# Technical Service Information

## THM 4L80-E

### HIGH LINE PRESSURE (NO BANANA PARTS)

Figure 1

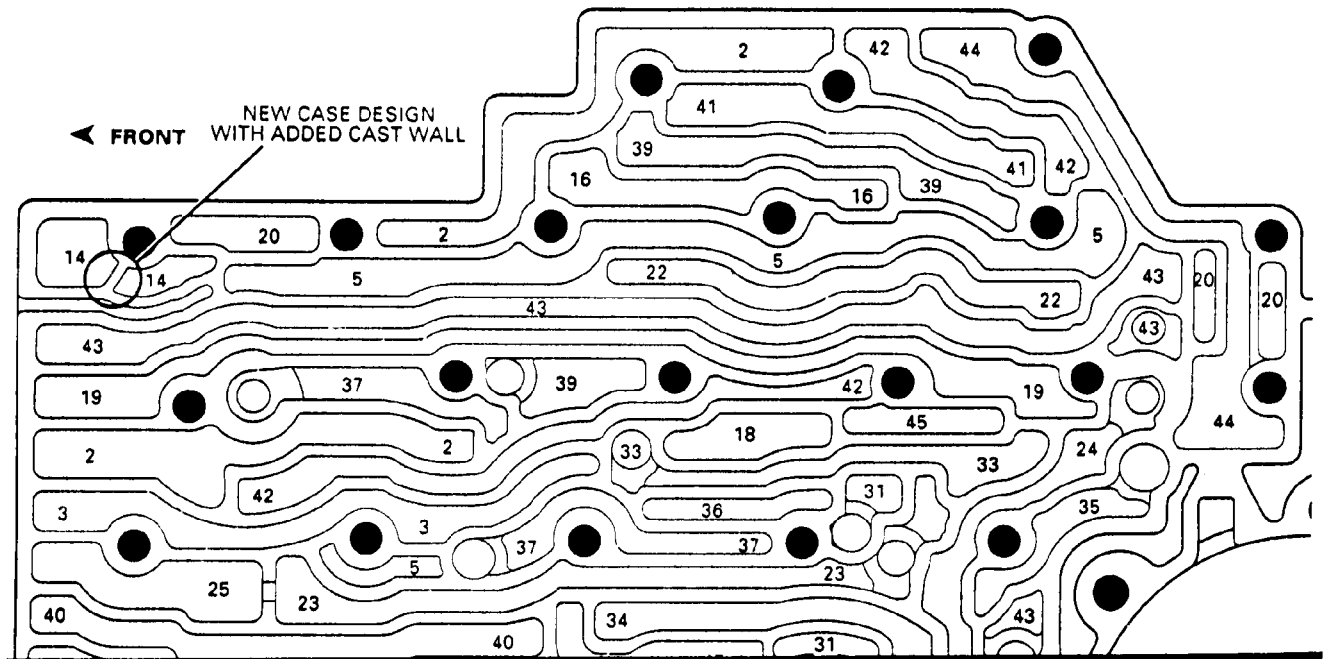
(1) TRANSMISSION CASE - Oil dam added in the torque signal circuit in the location shown in Figure 1, to orifice torque signal oil thru the revised spacer plate to the boost valve.

Figure 2

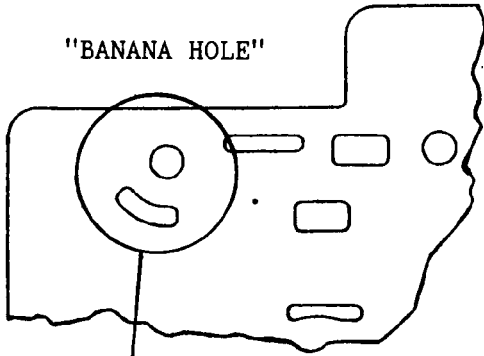
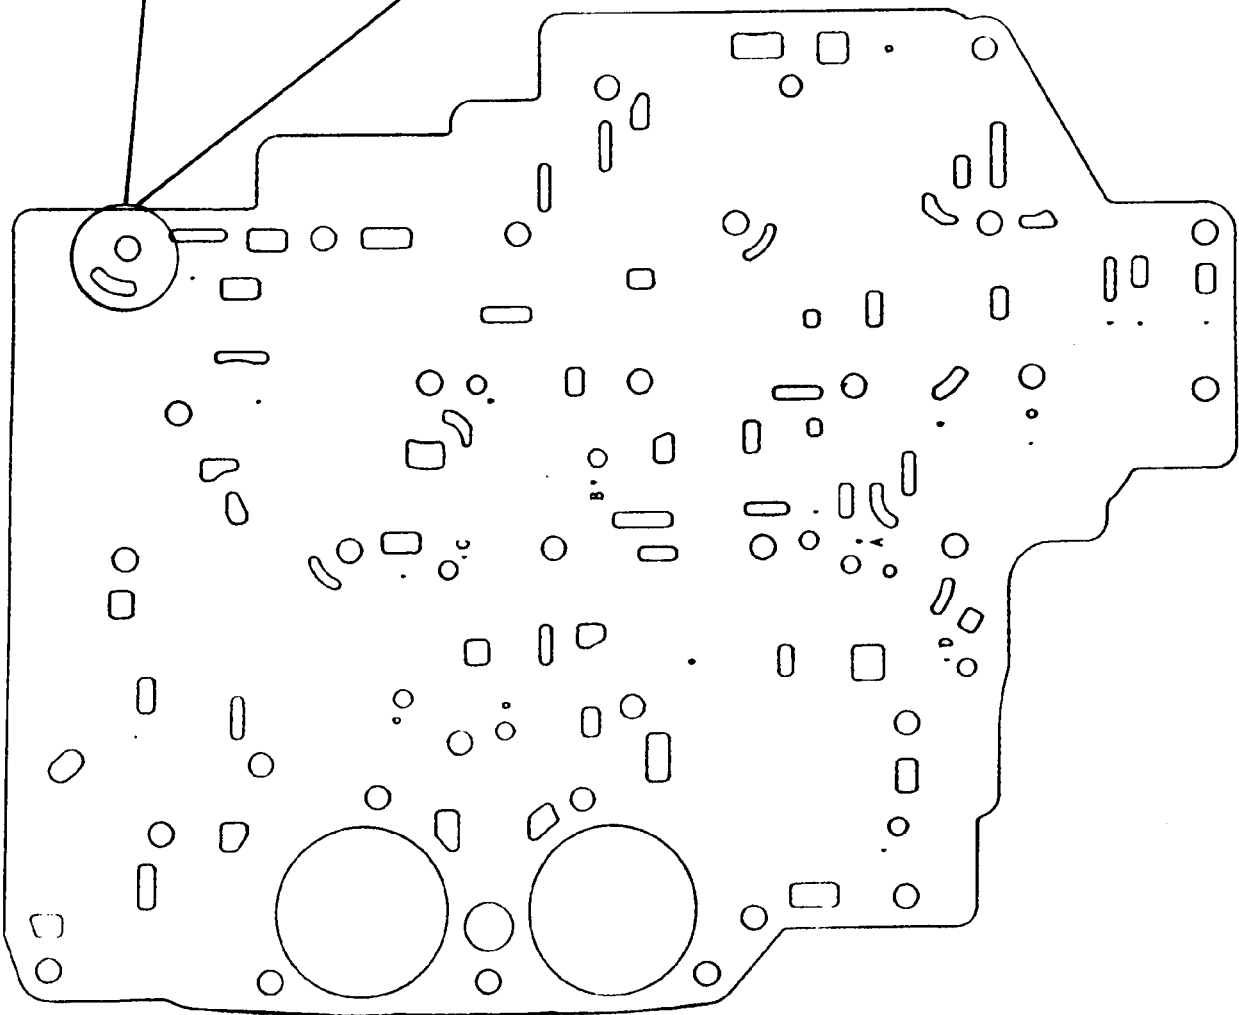
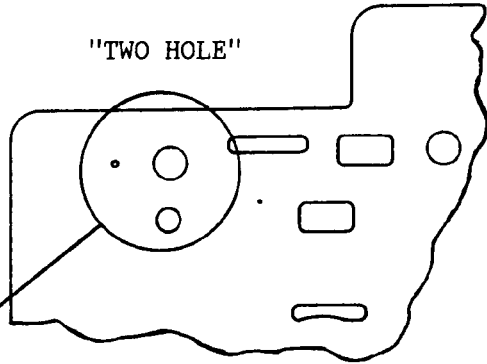
(2) VALVE BODY SPACER PLATE - The "Banana Hole" in the previous spacer plate was eliminated, with a round feed hole and orifice hole added on each side of the new dam in the case to make orifice effective (See Figure 2).

Figure 3

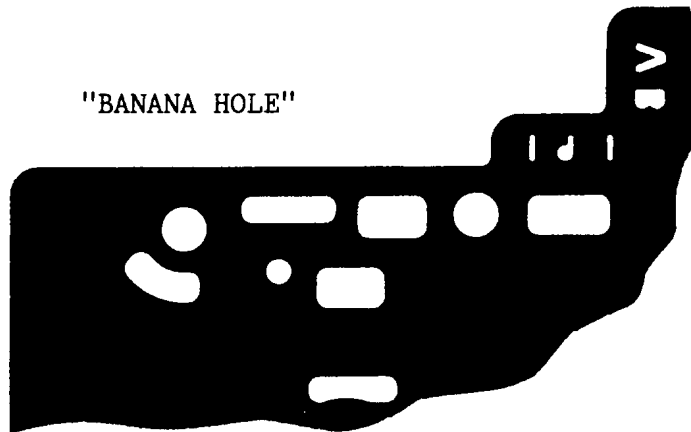
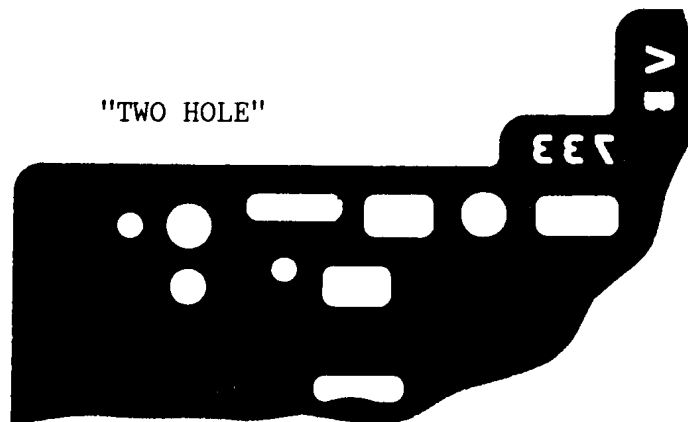
(3) SPACER PLATE GASKETS - Revised hole configuration to accommodate the new spacer plate and case, as shown in Figure 3.
